Reply to report of reviewer #1

“Validating global horizontal irradiance retrievals from Meteosat SEVIRI at increased spatial resolution against a dense network of ground-based observations by Wiltink et. al.”

Reply to report of reviewer #2

Figure 2: Flow diagram illustrating the required steps to derive time series of GHI from SEVIRI reflectances. The input data and processing are explained in Section 2 while the post-processing is explained in Section 3.

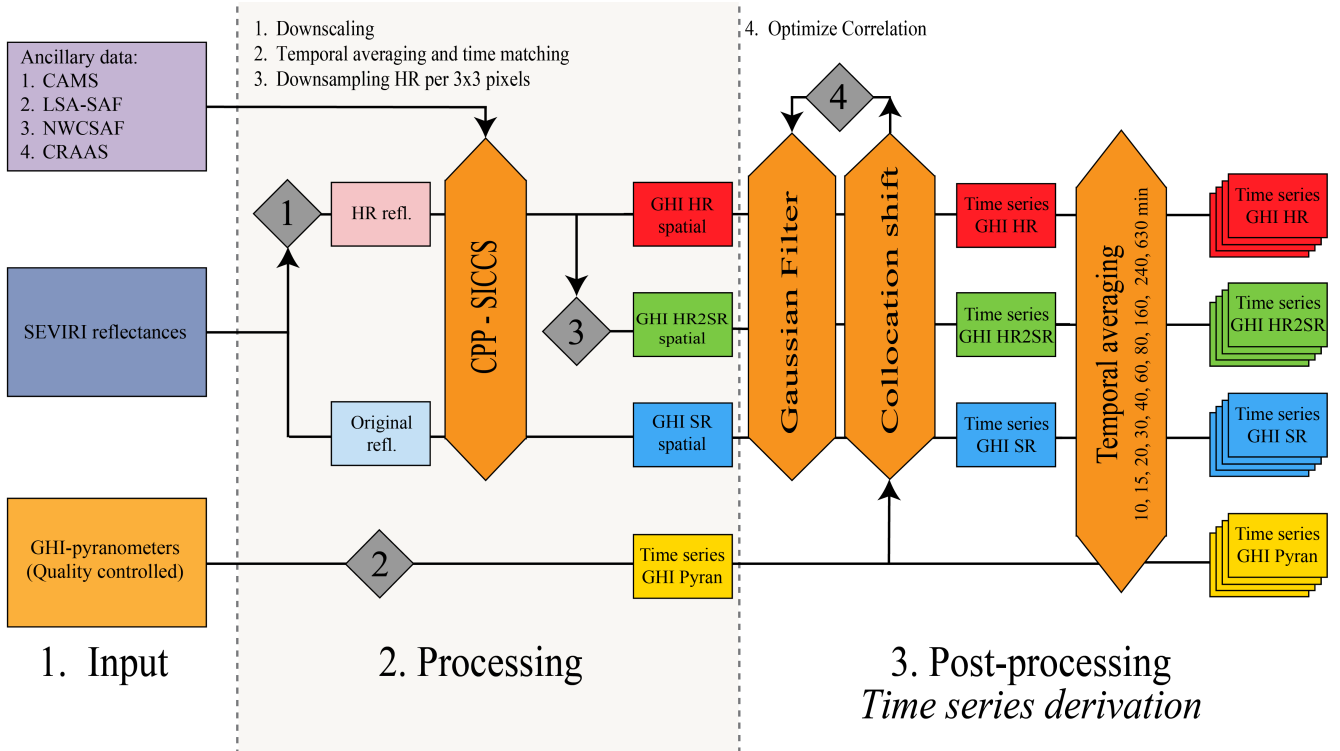
- 3) *I think that it would be eneficial a scheme or flow diagrama explaining or indicating the different steps and products used in the methodology in order to get easier for the reader the understanding.*

We have added a flow diagram (Fig. 2) to Section 2.2 of the manuscript, graphically illustrating the steps required to go from input data to satellite-derived time series. The figure is introduced as follows:

page 5, line 124 '... is presented in Deneke et al. (2021), and shown in a more compact form in the left hand side of Figure 2.
